**MONTVILLE WATER POLLUTION CONTROL AUTHORITY**  
**WASTEWATER TREATMENT FACILITY HEADWORKS IMPROVEMENTS**

**CONTRACT NO. 2021-5**

**ADDENDUM NO. 1**

GRIT SEPARATOR AND  
HEADWORKS DETAILS

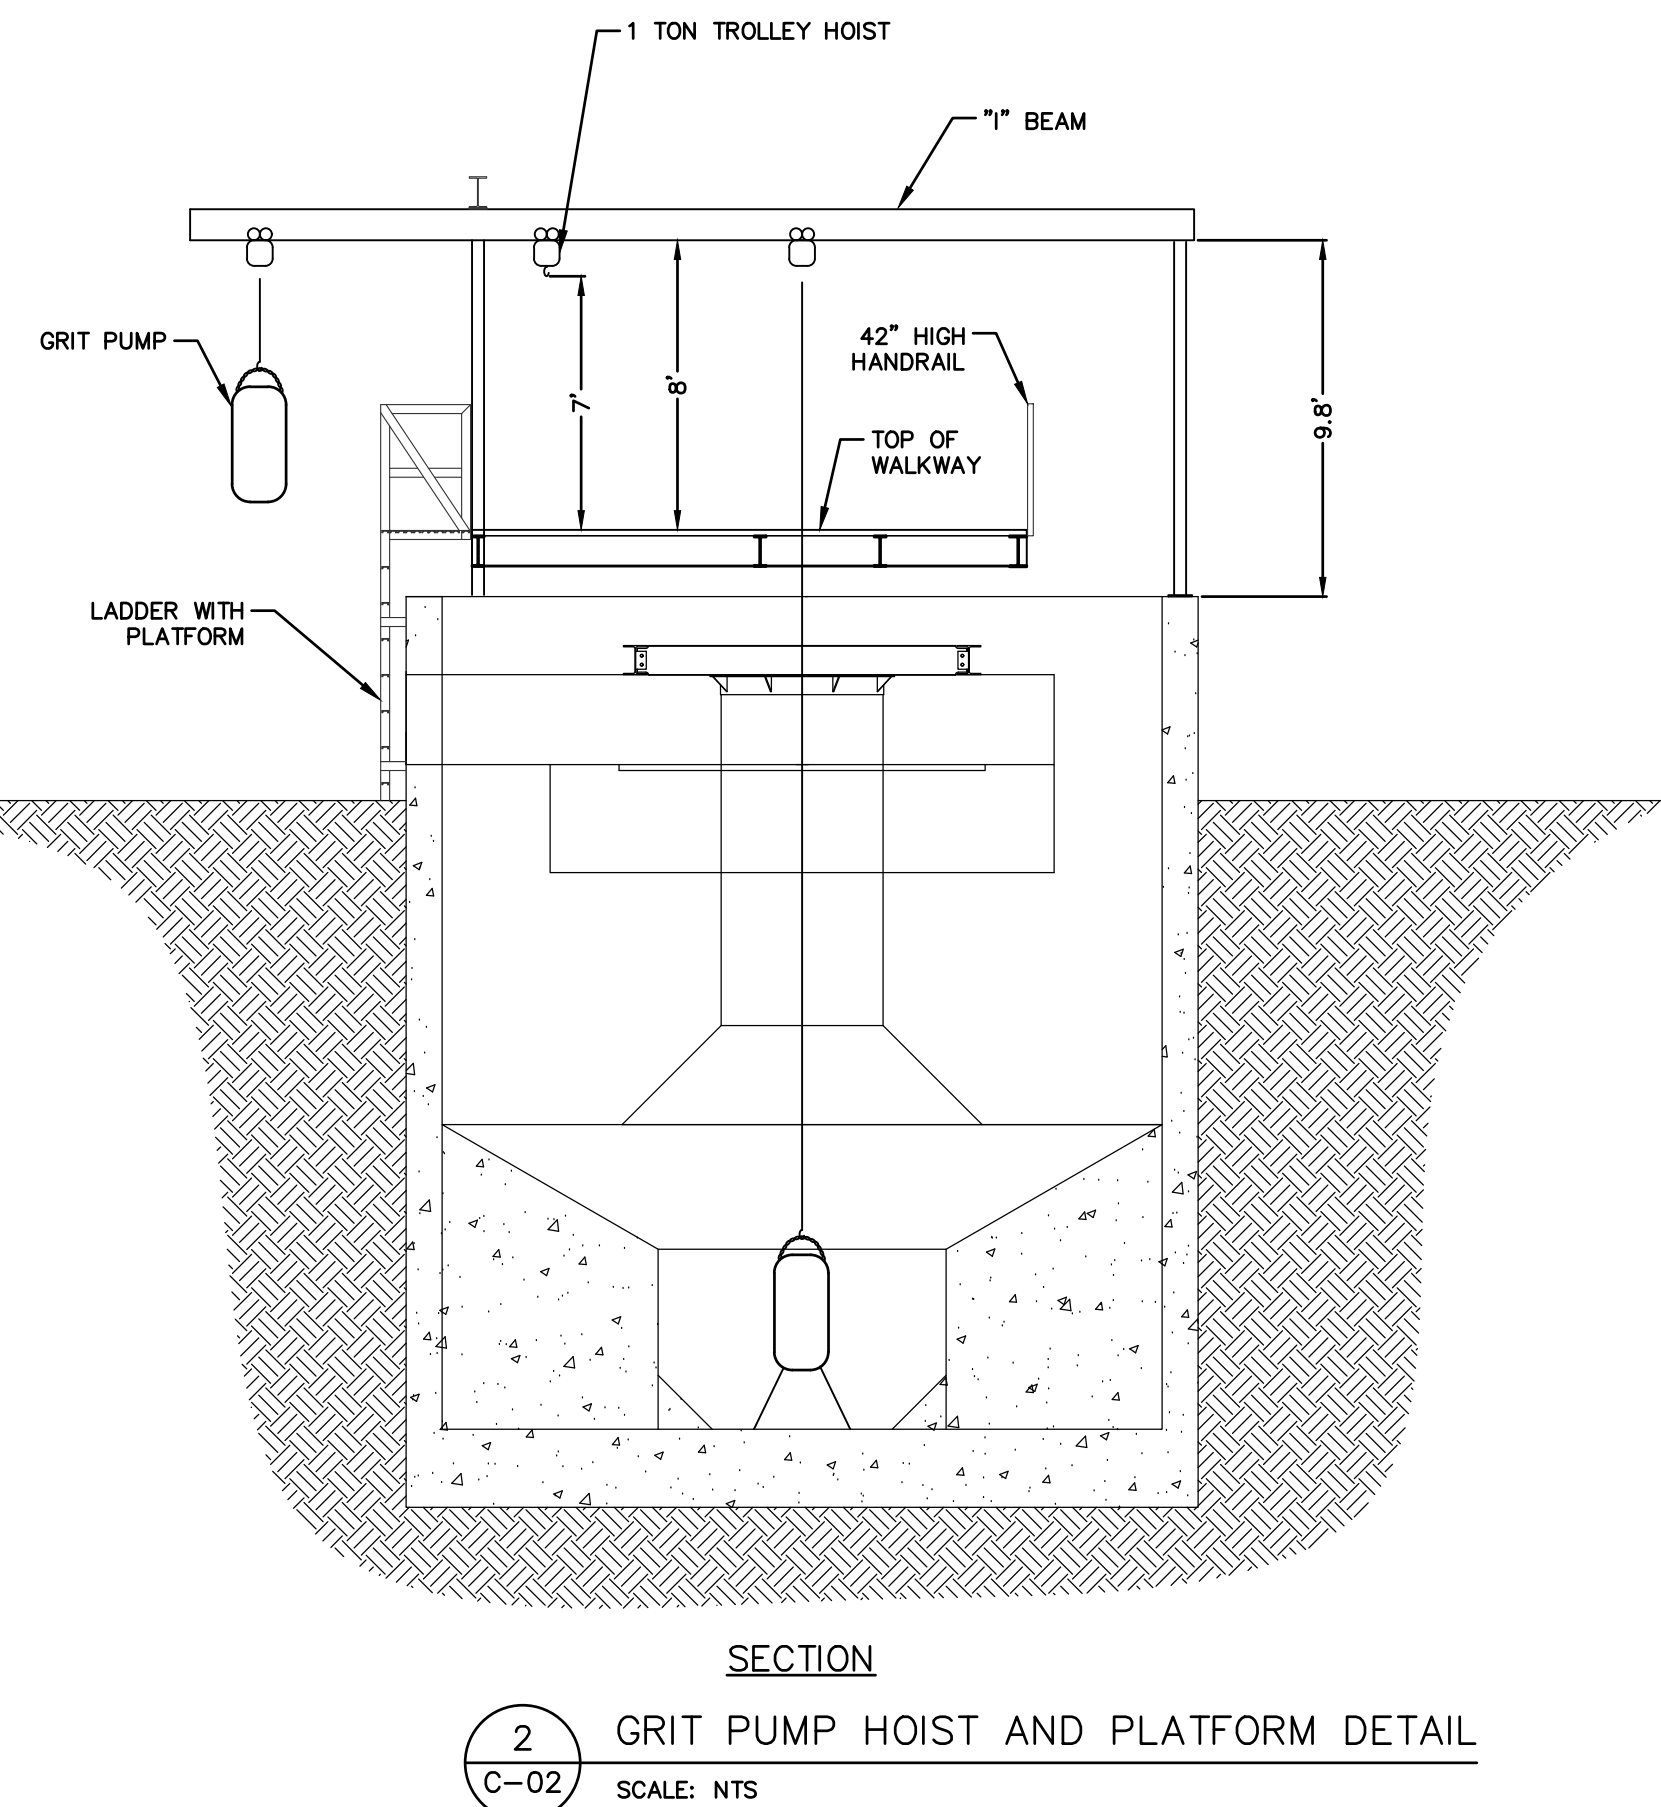
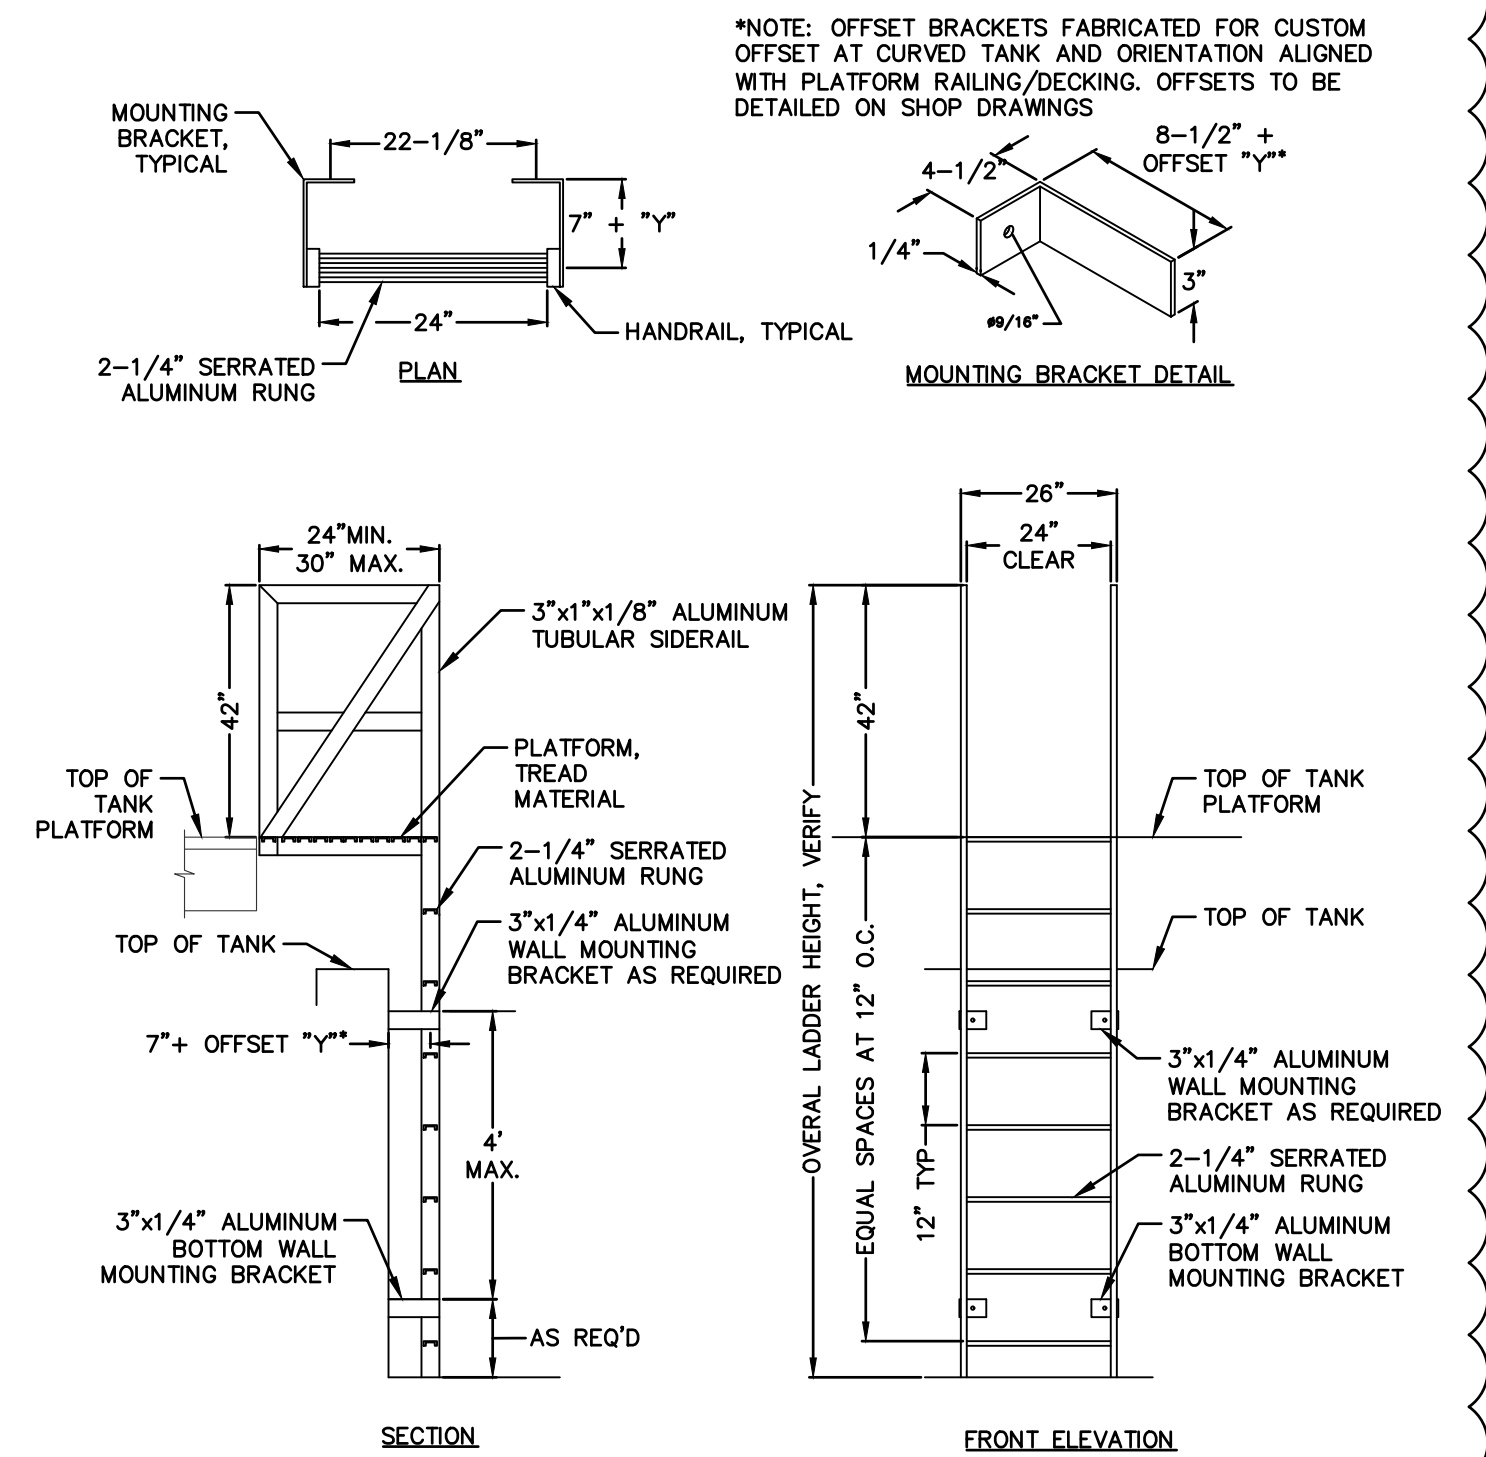
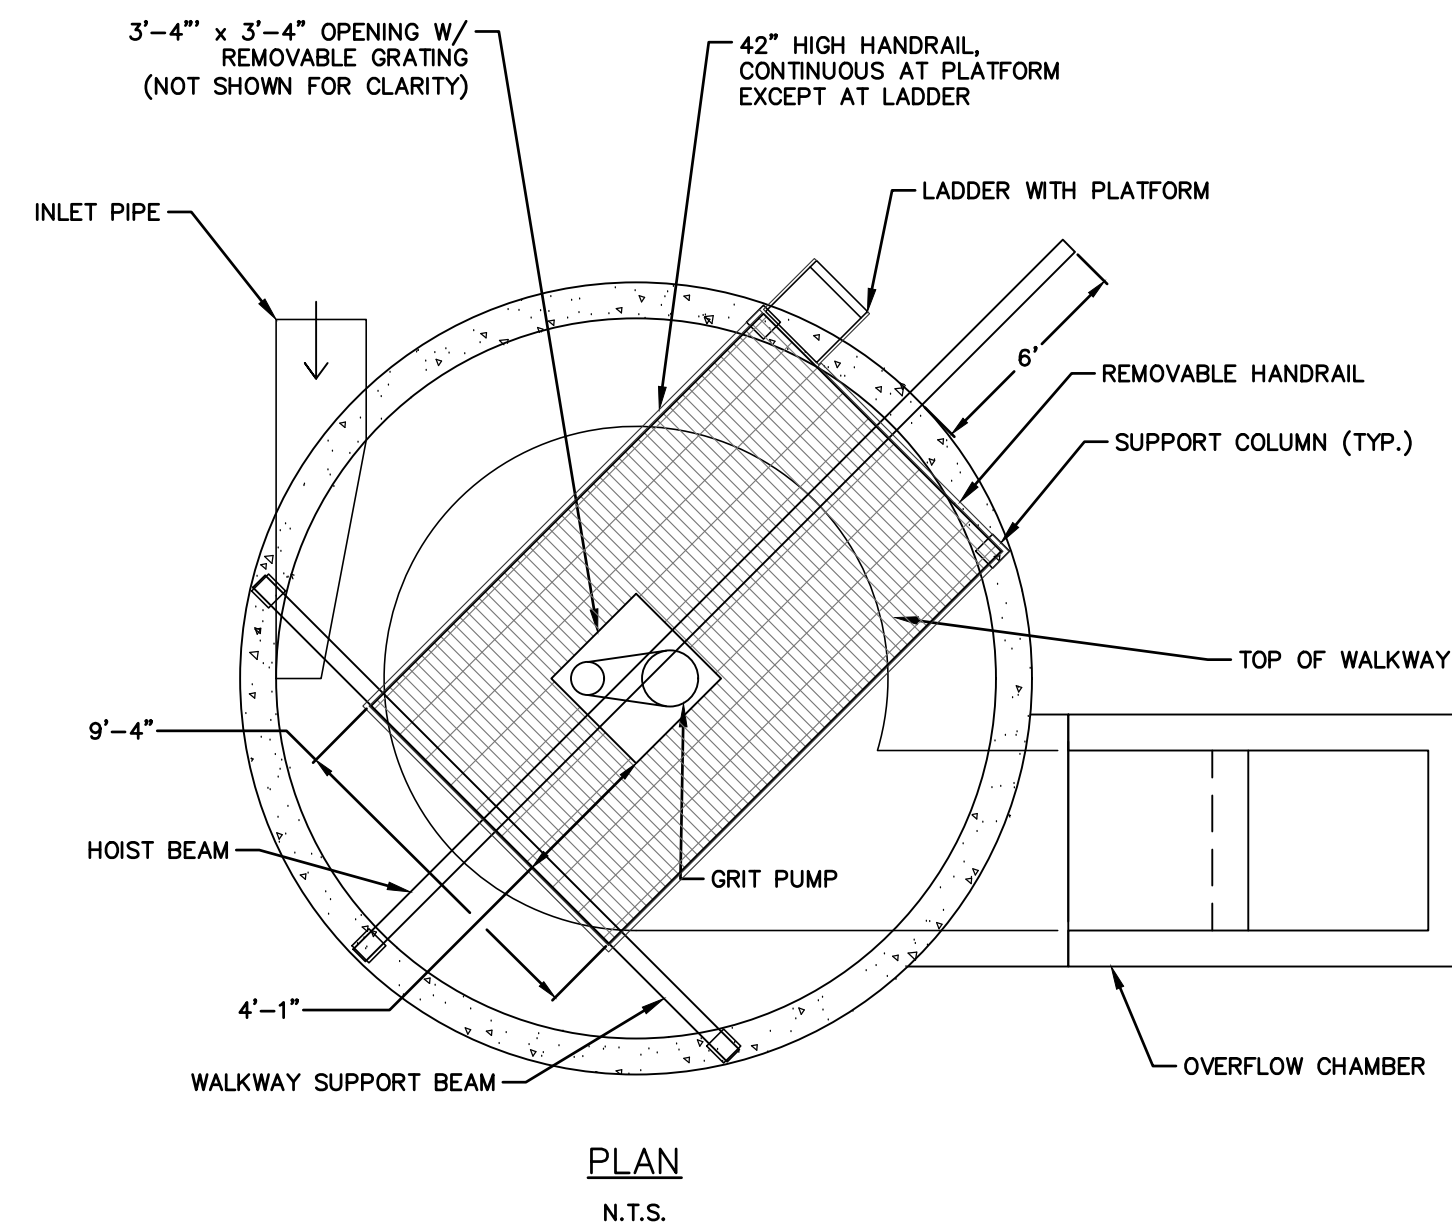
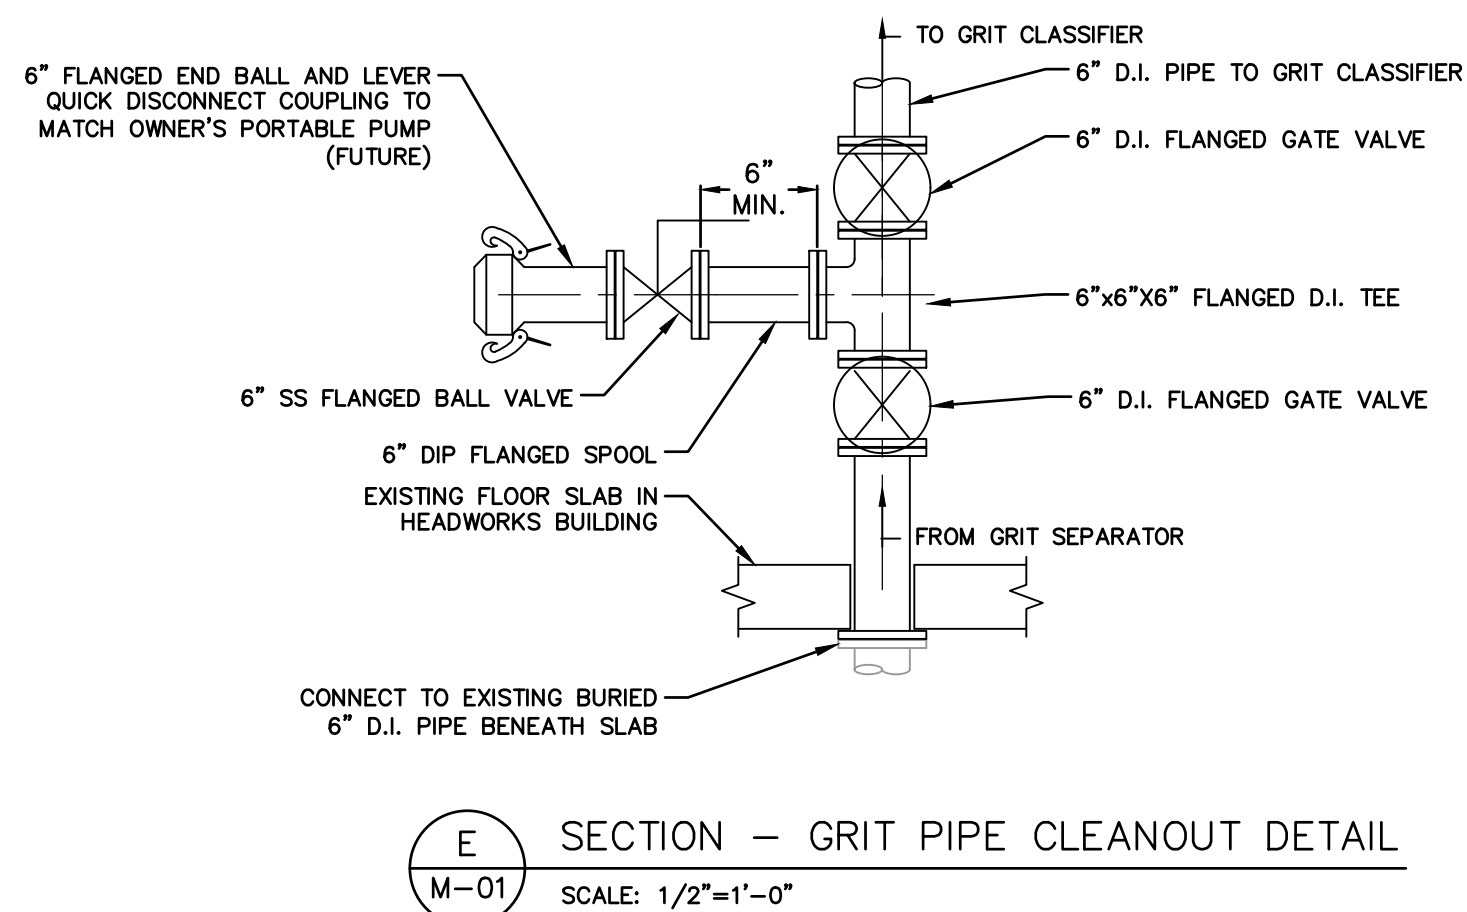
6. **DELETE WITHOUT REPLACEMENT:** Project manual Sections 03400, 'Precast Concrete Structures', Section 03401, 'Precast Concrete Exterior Structures', and Section 04816, 'Concrete Unit Masonry Assemblies'.
7. **ADD:** To project manual, Specification Section 05513. 'Metal Ladders', Attachment 003.
8. **DELETE AND REPLACE:** Drawing M-02 with revision made to Detail 2/C-02 and added detail 3/M-02, Attachment 004.
9. **DELETE AND REPLACE:** Project Manual, Table of Contents, Attachment 005.

2. **Question** - Reviewing sheet S-501 @ Guardrail (13/S-501), please provide the extent of the guardrail? Are there any gates? If so, please provide details and locations.

**Response:** Refer to drawing sheet M-02, Detail 2, Plan View, railing to completely enclose grate platform except at access ladder.
